DEVIATION REQUEST AND DECISION FORM

Project Name : Claremont Business Park 2 Filing No. 2

A deviation from the standards of **Table 2-7. Roadway Design Standards for Urban Collectors and Locals-** of the Engineering Criteria Manual (ECM) is requested.

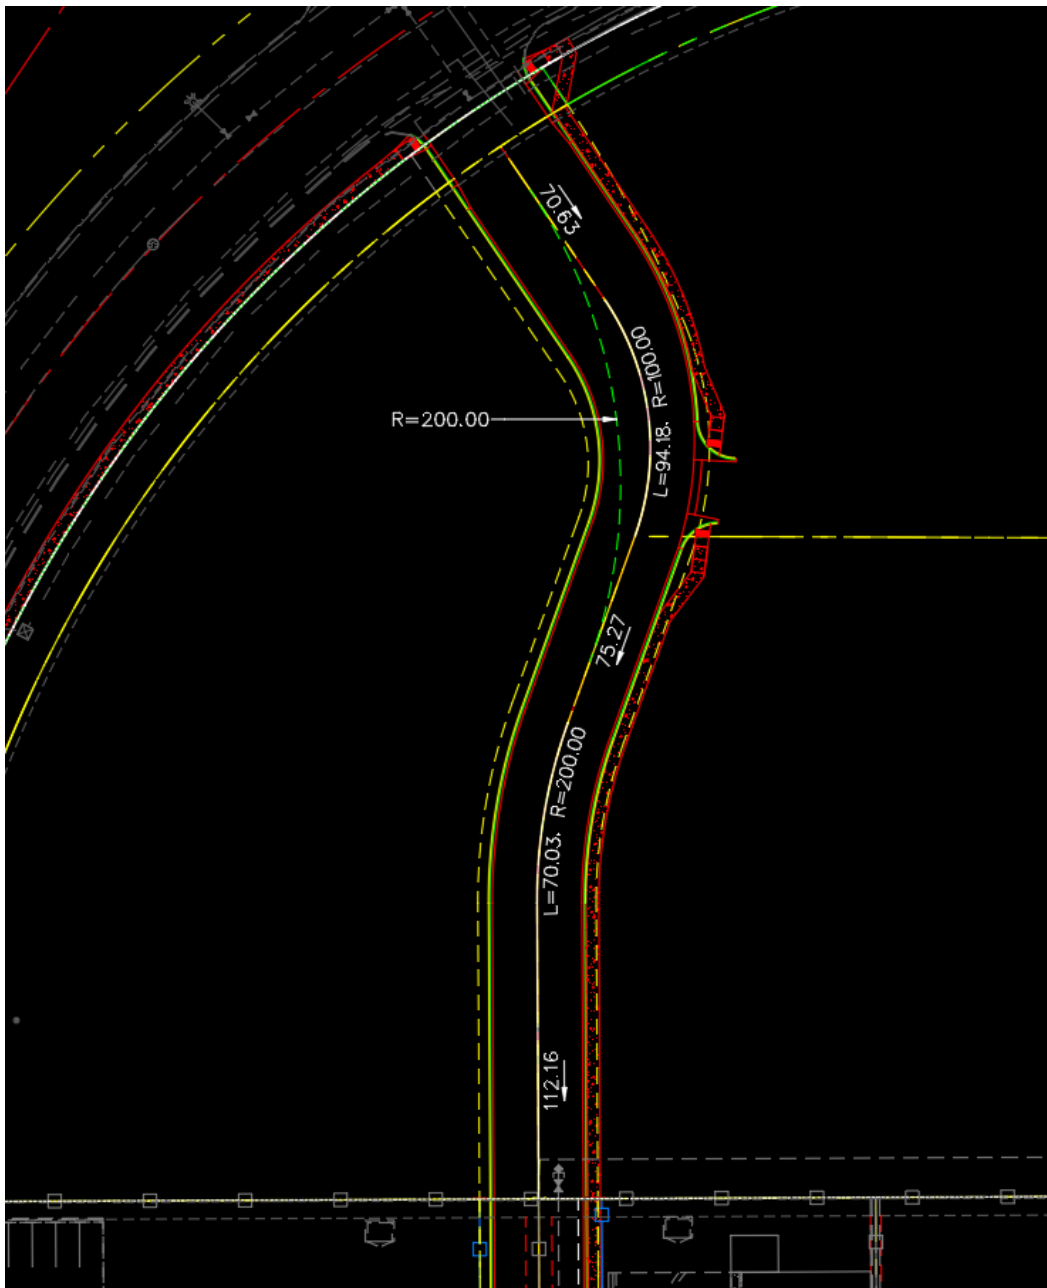
- We request approval of a 100' minimum centerline radius, whereas the radius requirement is 200' at (1) one (north curve) curvilinear location within the El Jefe Heights roadway. Meeting the 200' radius requirement would inhibit adequate distance between the two proposed curves. See the image below of the proposal for the 100' vs. the 200' radius requirement.

This request has been determined to have met the criteria for approval. A deviation from Section 2.2.4.B.6/SD-4-1 of the ECM is hereby granted based on the justification provided.

Deviation Request is approved since this is a private road not owned/maintained by EPC and is not being used for through traffic.

NOTE: El Jefe Heights will not be maintained by El Paso County until and unless the streets are constructed in conformance with EPC standards in effect at the date of the request for dedication and maintenance. This includes realigning the road from the 100' centerline radius centerline radius approved with this deviation request to the County minimum 200' centerline radius.
